DANE COUNTY DEPARTMENT of PUBLIC WORKS, HIGHWAY and TRANSPORTATION

RFB NO. 313083 - ADDENDUM NO. 3

CONSTRUCTION OF EAST HIGHWAY GARAGE – SALT STORAGE FACILITY (BID PACKAGE A) AND MEDICAL EXAMINER OFFICE BUILDING (BID PACKAGE B)

**DEPARTMENT OF PUBLIC WORKS,
HIGHWAY & TRANSPORTATION
3562 COUNTY HIGHWAY AB
MCFARLAND, WISCONSIN**

6 LOWER CANOPY FRAMING PLAN
SCALE: 1/4" = 1'-0"

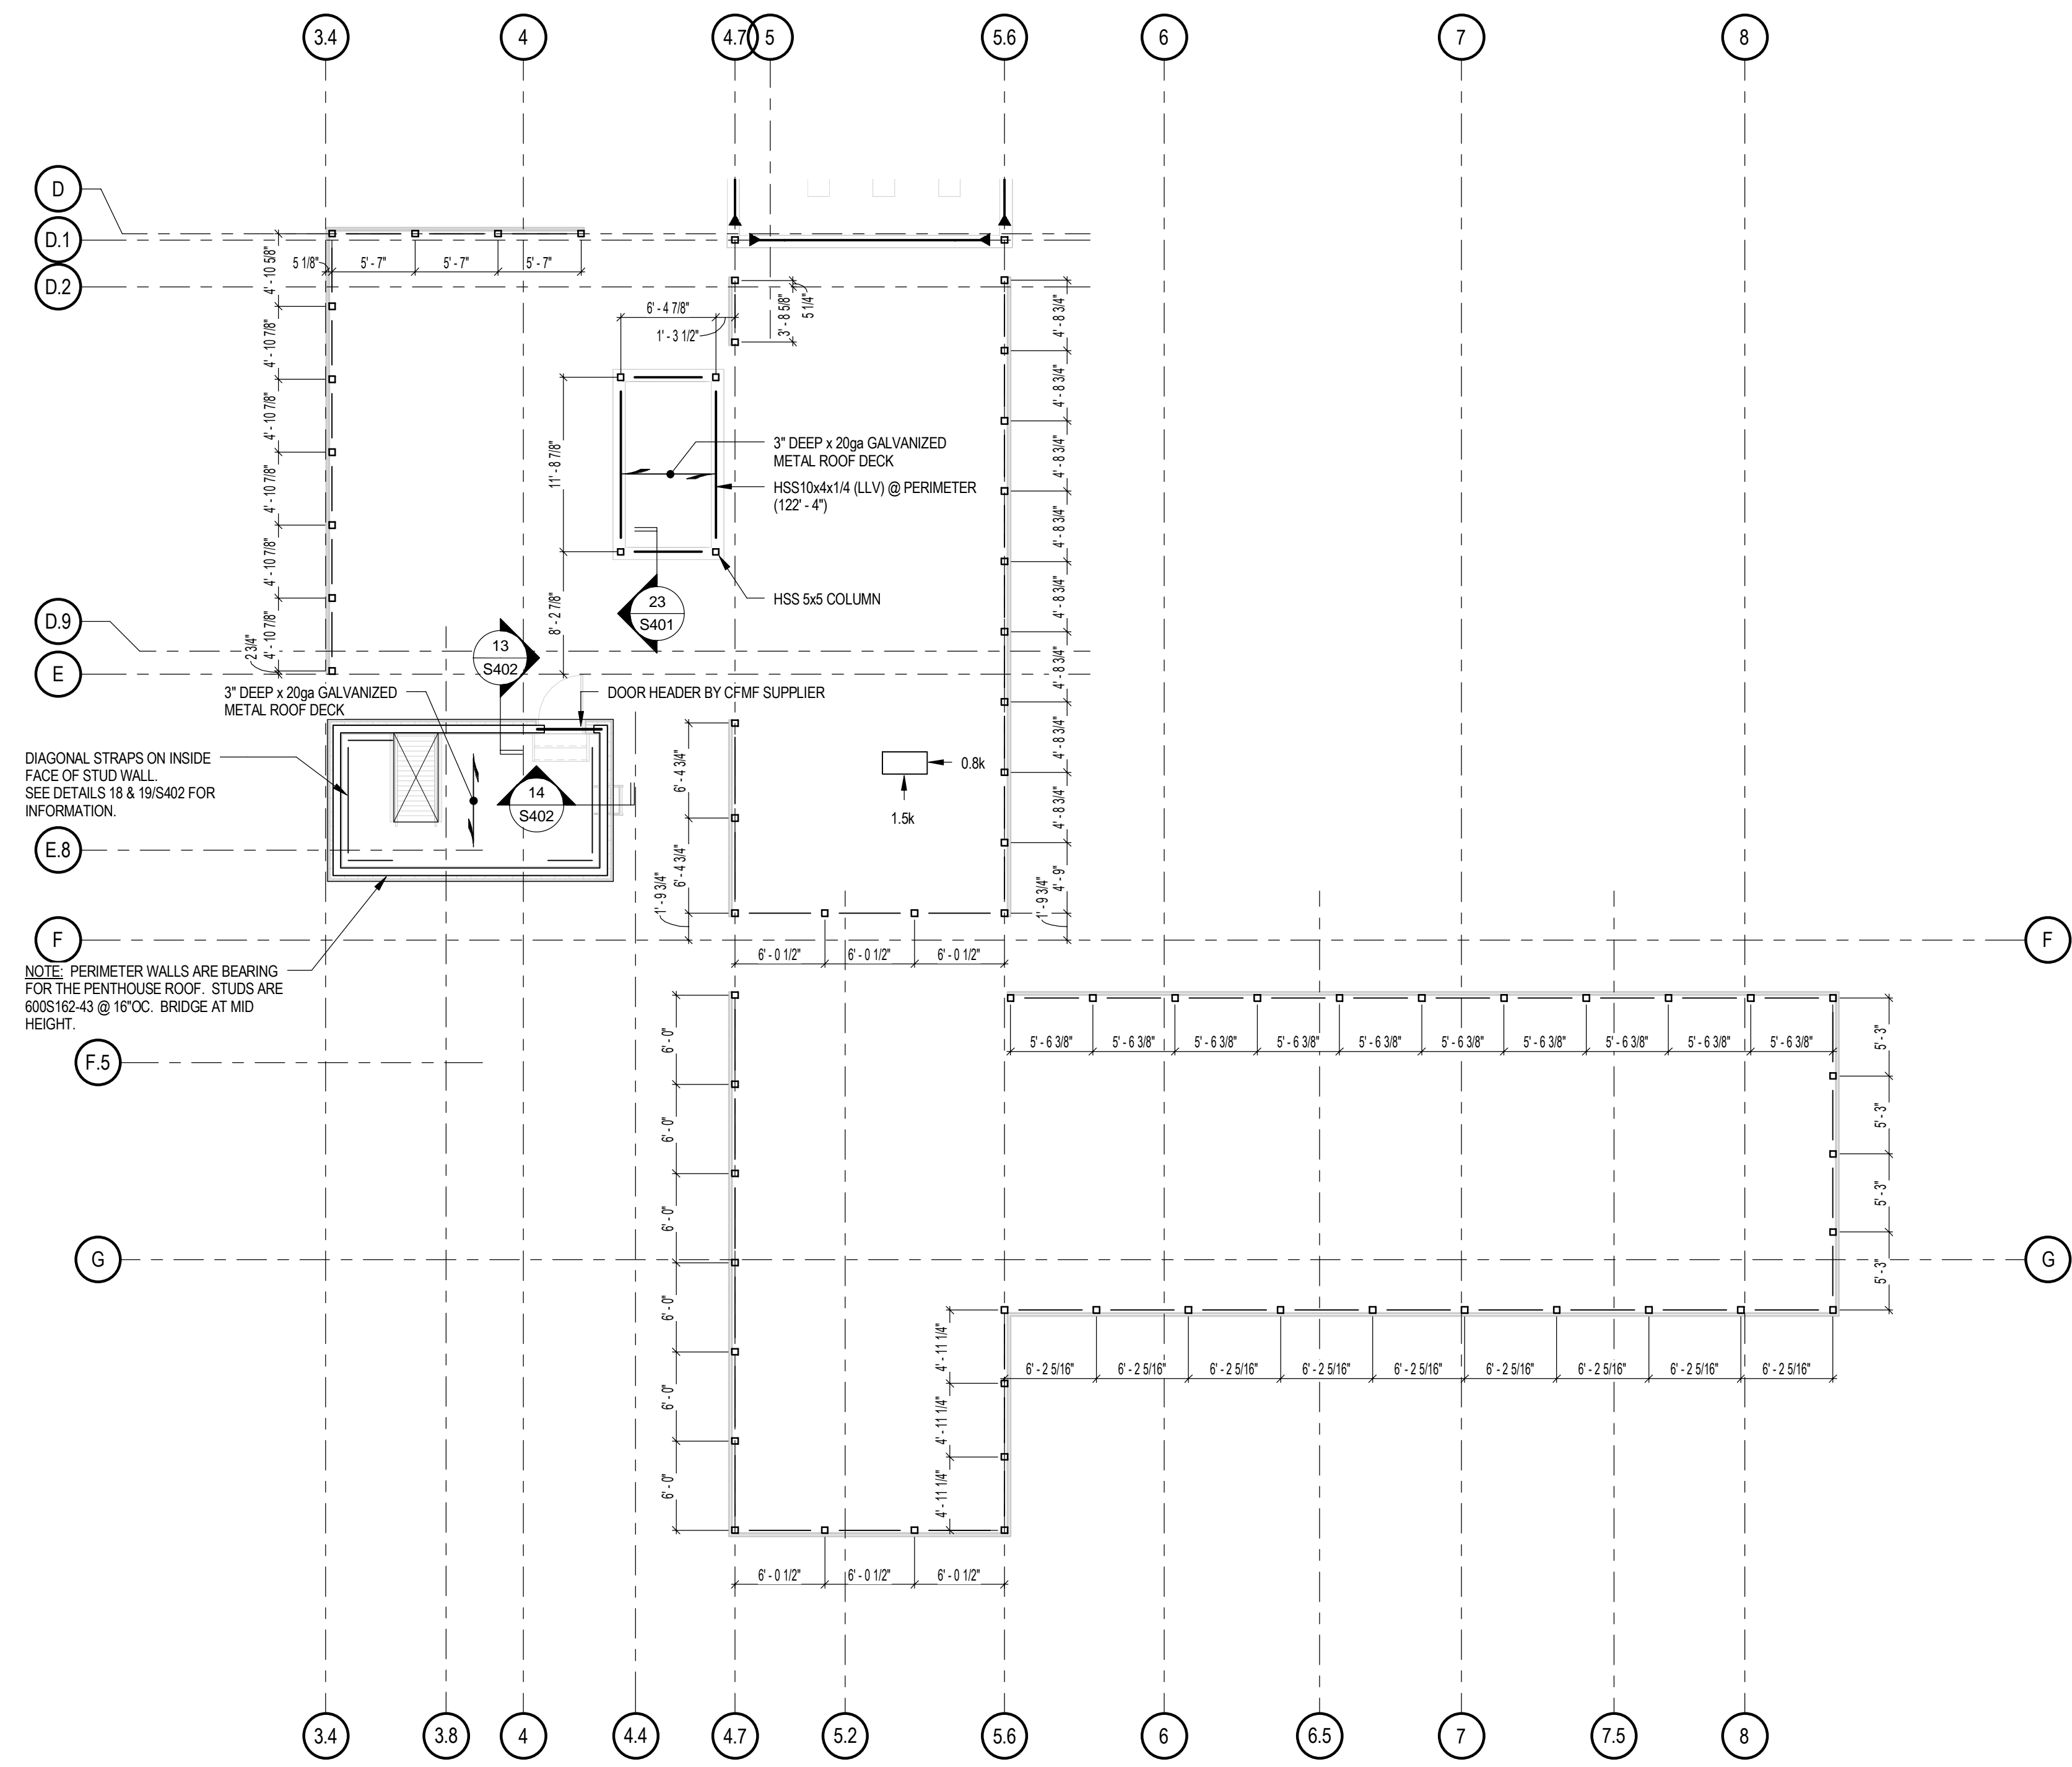
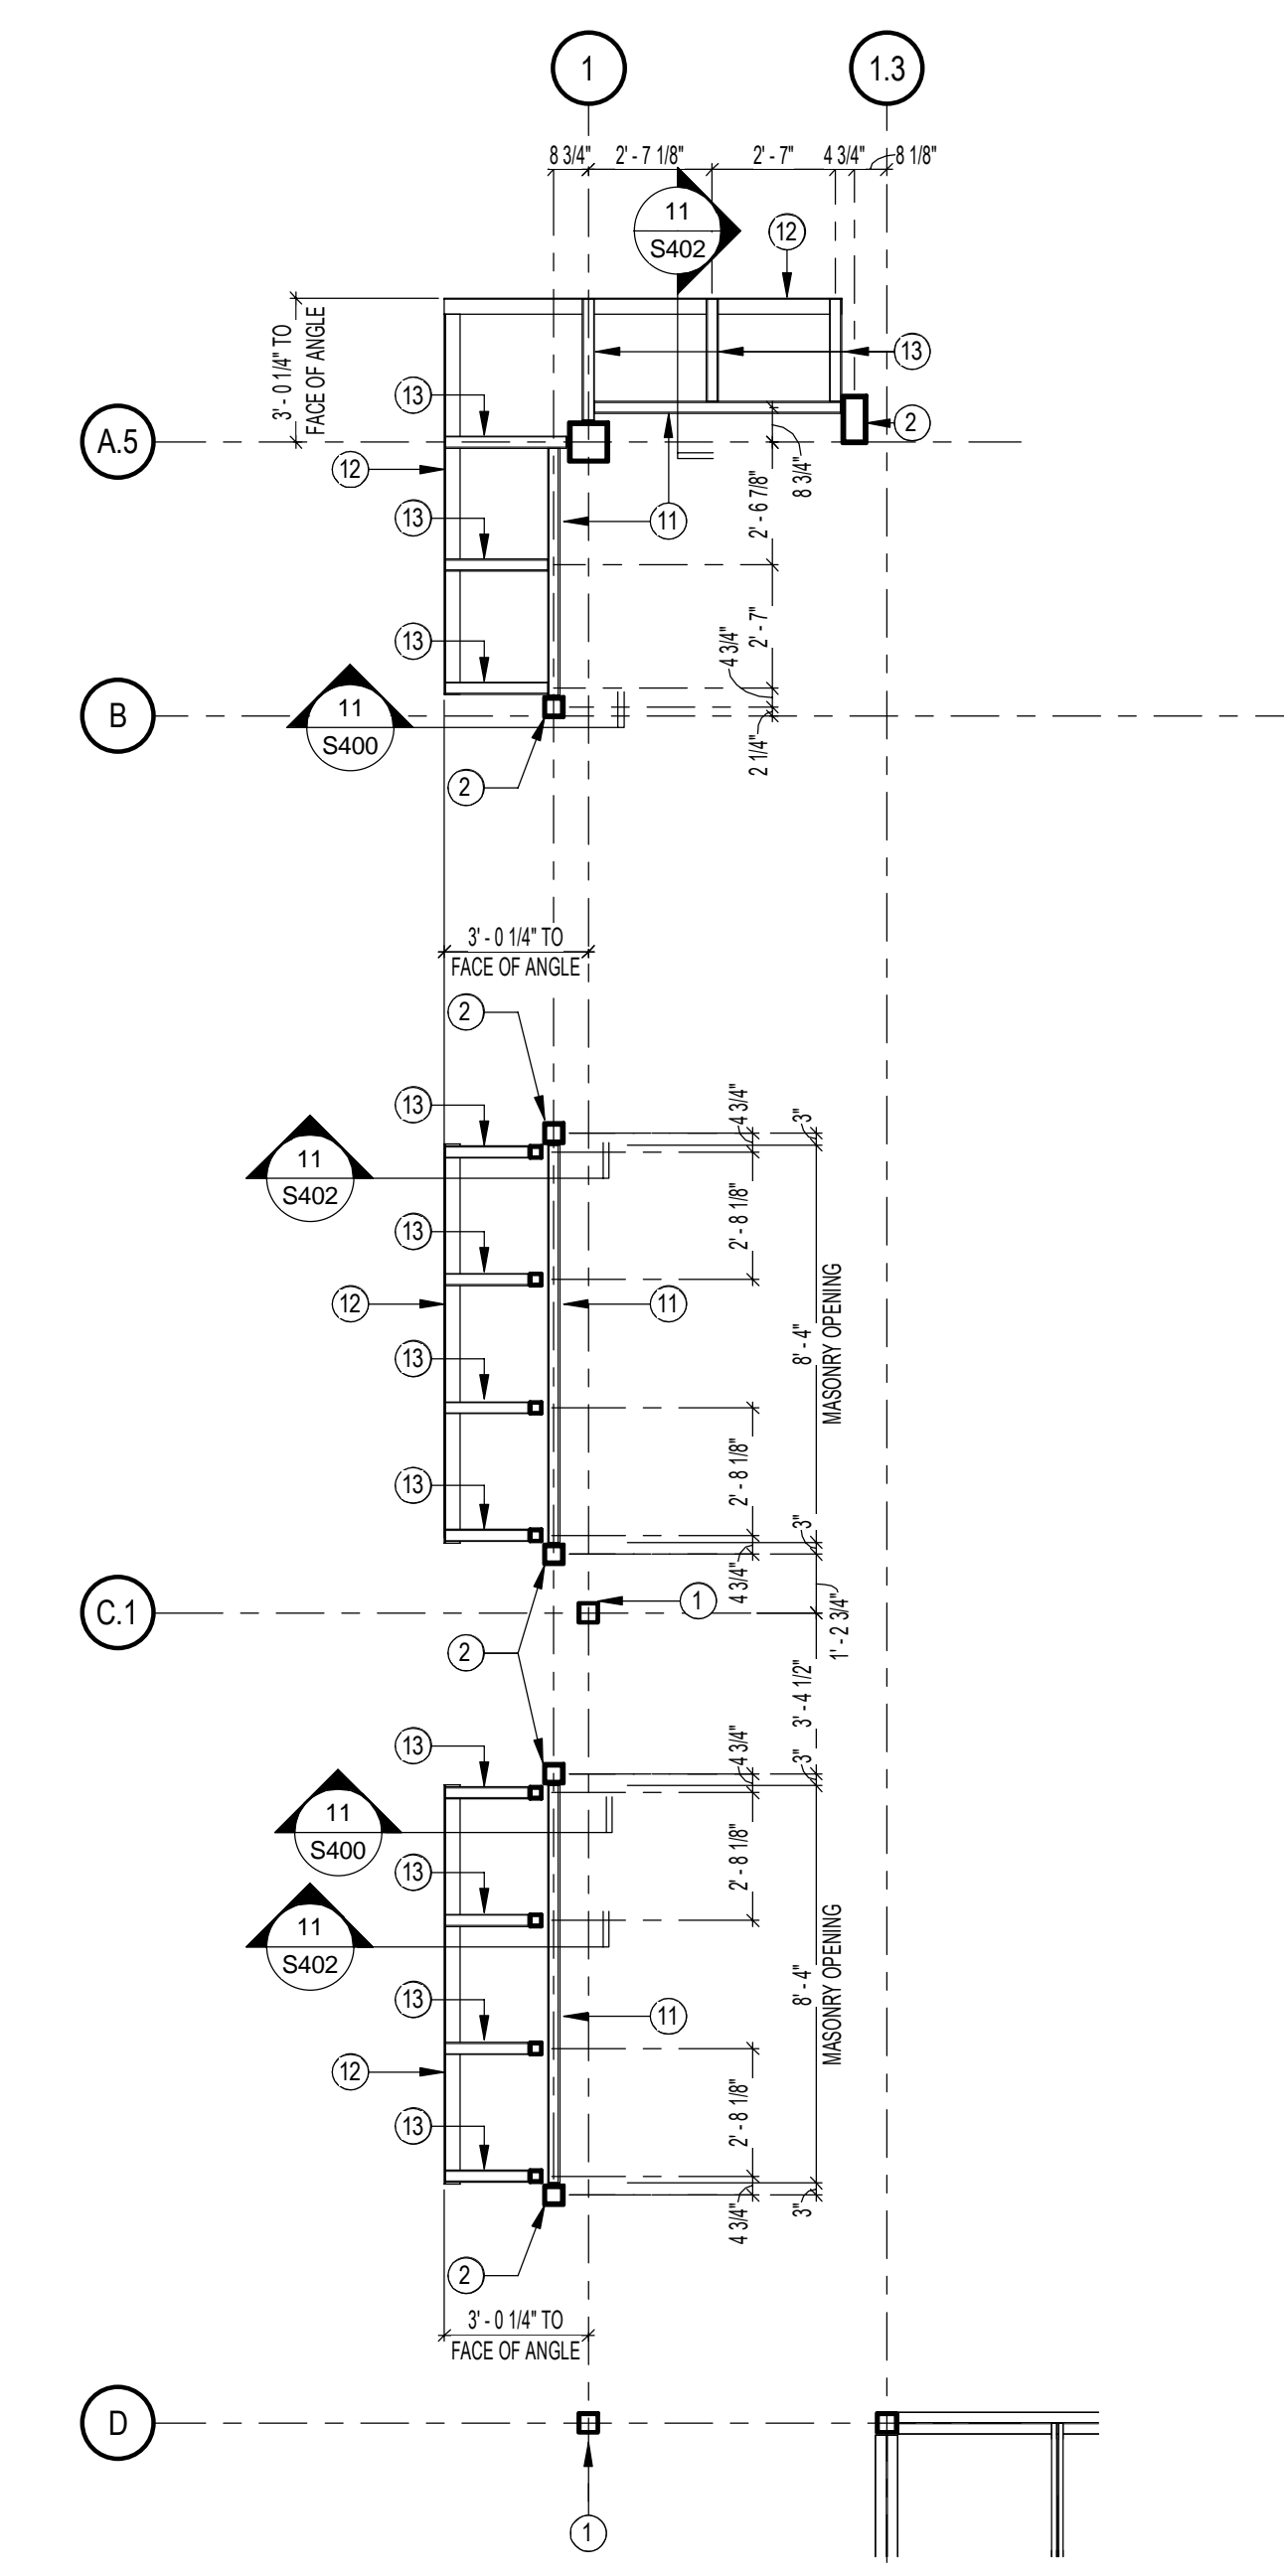
22. SHEET S200:
 - a. Replace in its entirety.
 - b. Detail 1/S200.
 - i. Revised joist size in the area of grids D.1/E and 5.6/6 to eliminate the "special" joists.

- ii. Added a note for the weight of EF-3 in the garage area.
 - iii. Added general note 4 relative to the use of AESS.
 - c. Detail 2/S200.
 - i. Eliminated the detail.

4. QUESTION/COMMENT
- a. Plan sheet S200 - Please provided the weight of the EF-3 unit along column line 11 of the Garage?
- AE RESPONSE
- a. Refer to addendum.

- a. No, bid as per Contract Documents. The submitted product information did not meet all the specification requirements.
12. QUESTION/COMMENT
- a. Question on sheet S200 the load diagram for joist 22KSP1.

- AE RESPONSE
- a. Refer to addendum.
13. QUESTION/COMMENT
- a. Question on sheet S200 and the application of detail 2/S200.
- AE RESPONSE
- a. Refer to addendum.
